CITY OF ALBUQUERQUE

RE: 2532 Carson NW

Grading and Drainage Plan Engineer's Stamp Date: 07/22/24

Hydrology File: J12D035

2532 CARSON RD DRAINAGE PLAN

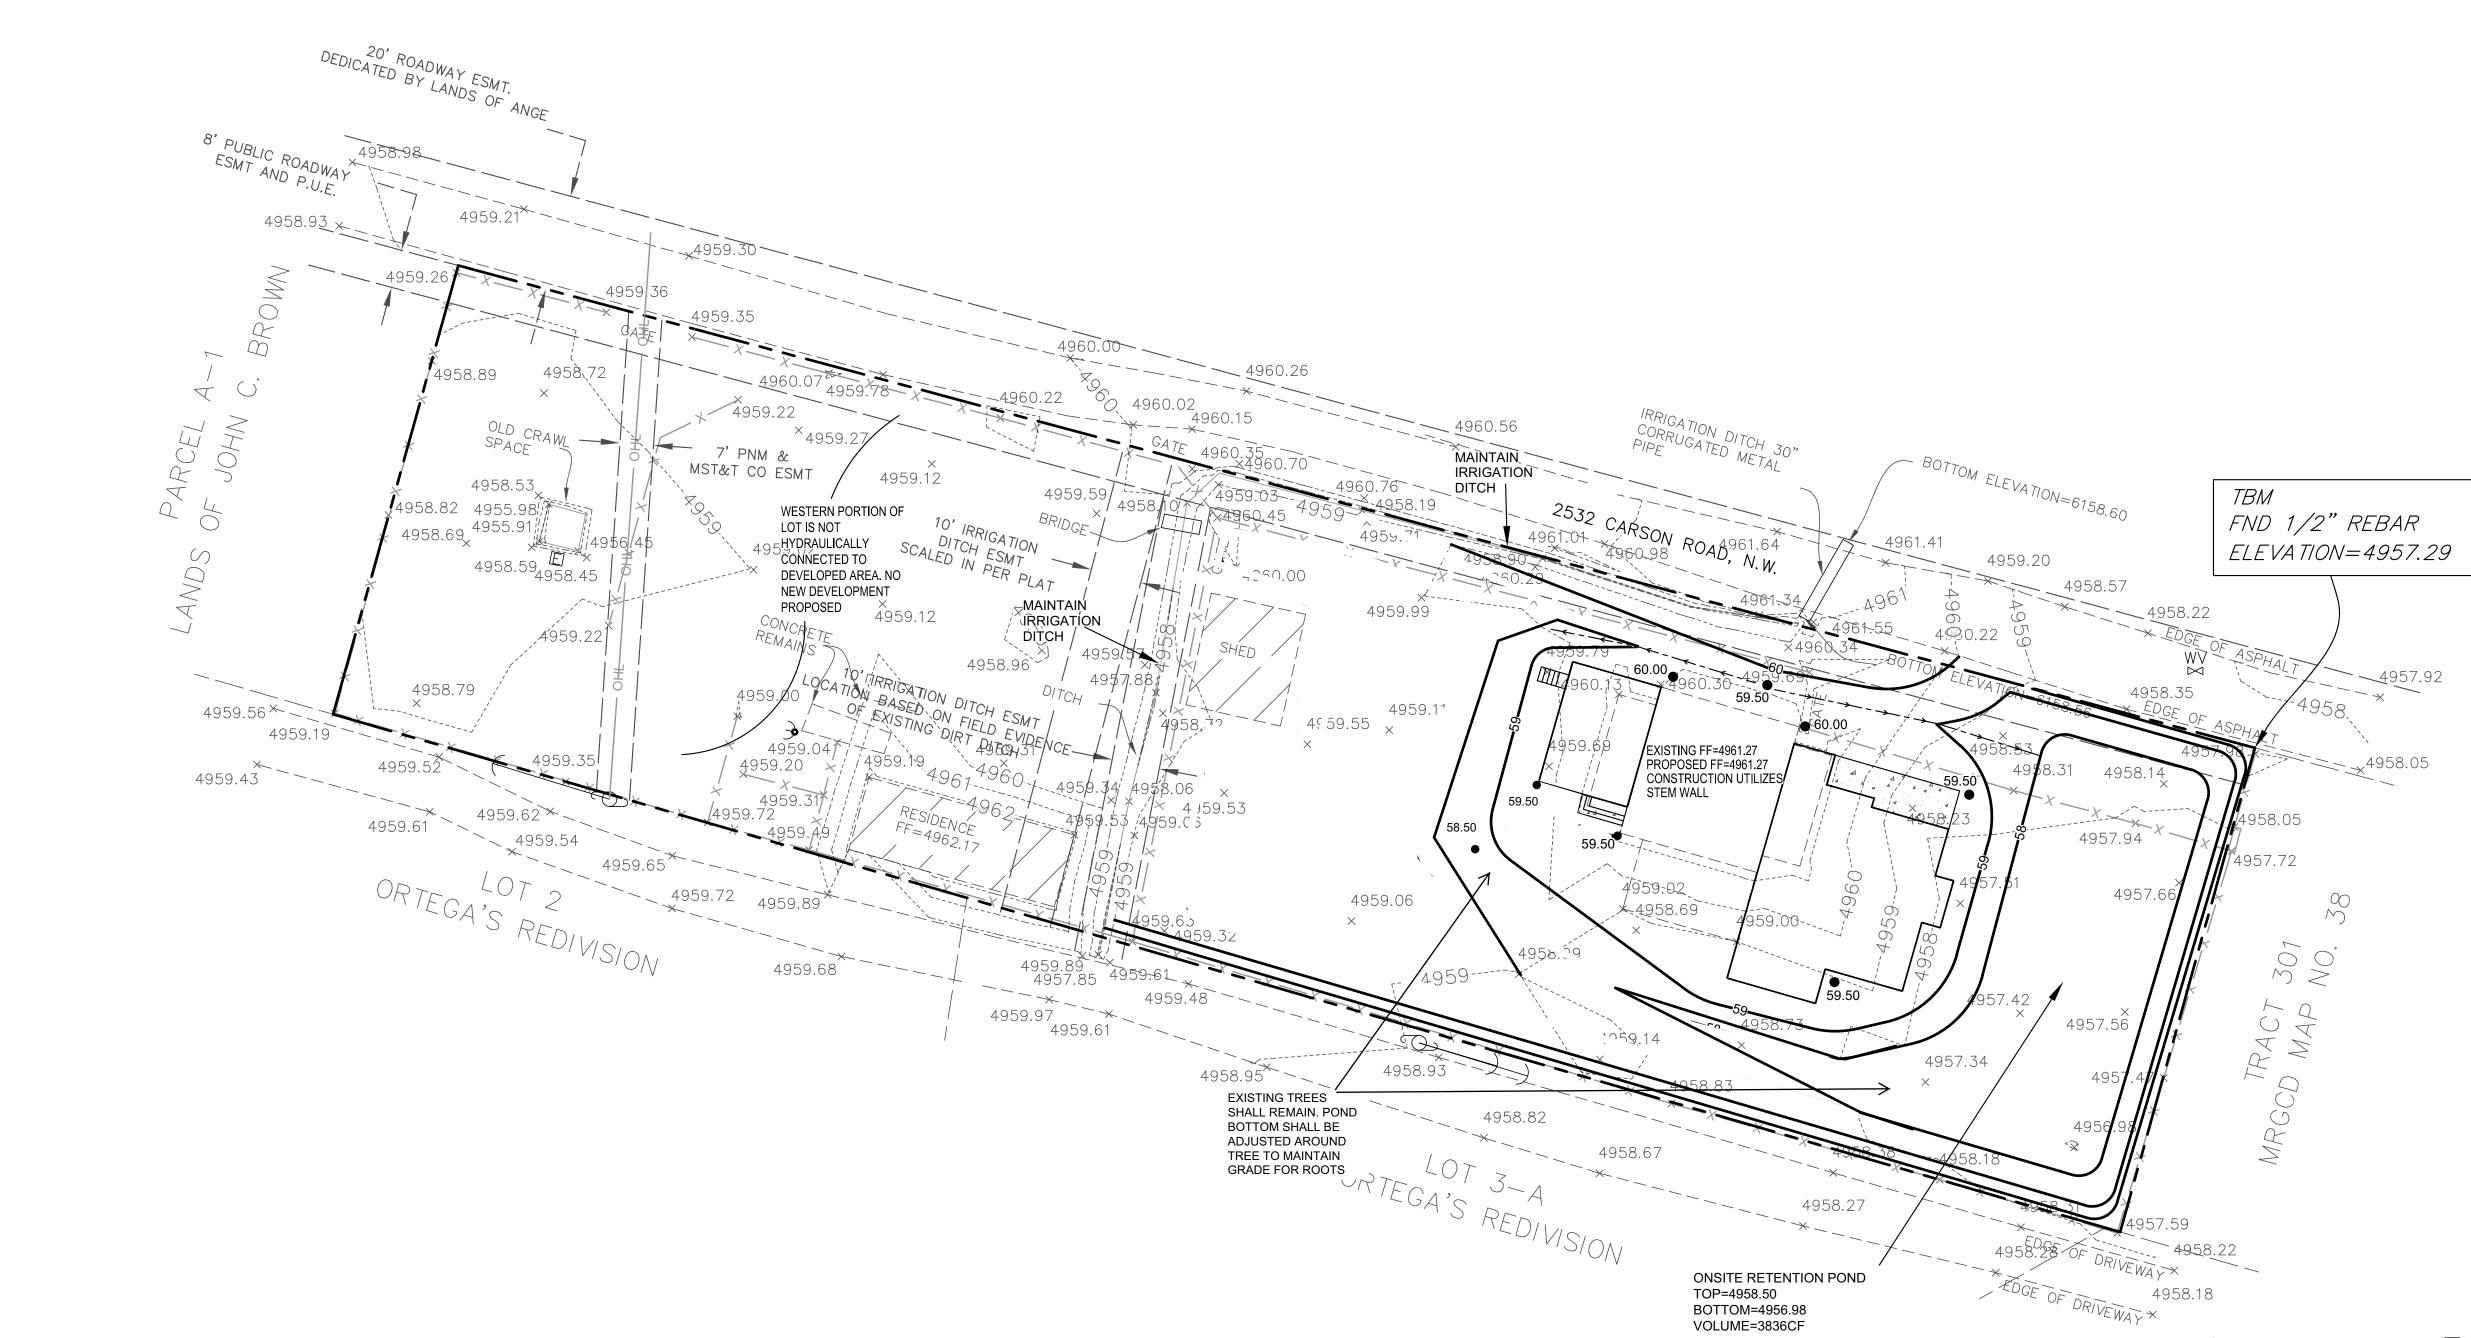
Based upon the information provided in your submittal received 07/22/2024, the Grading and Drainage Plan is approved for Building Permit. Since this site is an addition to an existing structure, a pad certification is not needed for this project. Please attach a copy of this approved plan in the construction sets for Building Permit processing along with a copy of this letter.

1. Engineer's Certification, per the DPM Part 6-14 (F): Engineer's Certification Checklist For Non-Subdivision is required.
